INDESIT company

Model type:
DSG573S

Commercial code:
F063167

n4513g02: INTRODUCTION OF NEW SYNCHRONOUS MOTOR

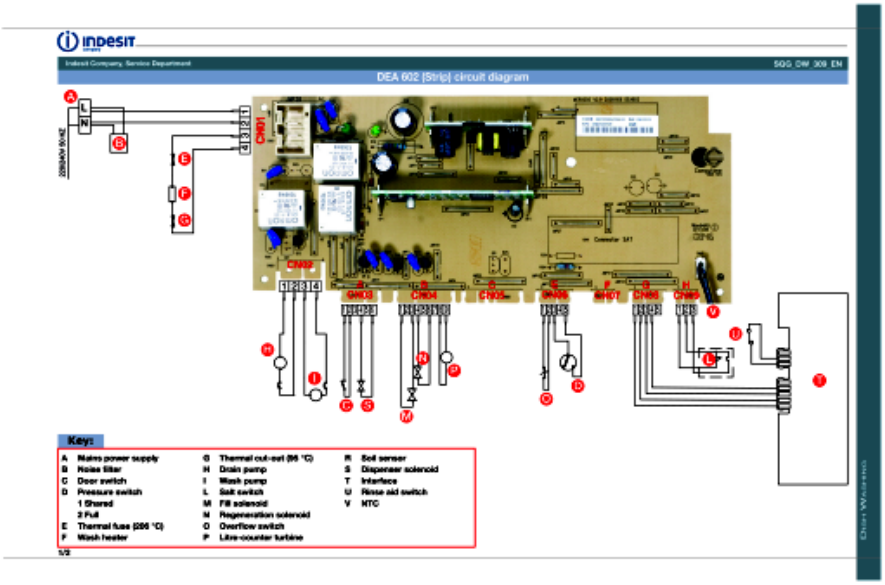
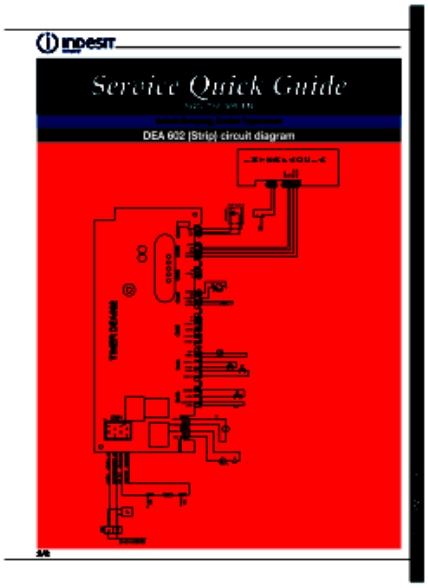
A new electropump has been introduced in the synchronous motor. This is perfectly interchangeable with the previous one, only the dowel has been modified improving its quality.

New motors have new codes:

Old New
C00256523 -> C00302800
C00256525 -> C00302798
C00272798 -> C00302796
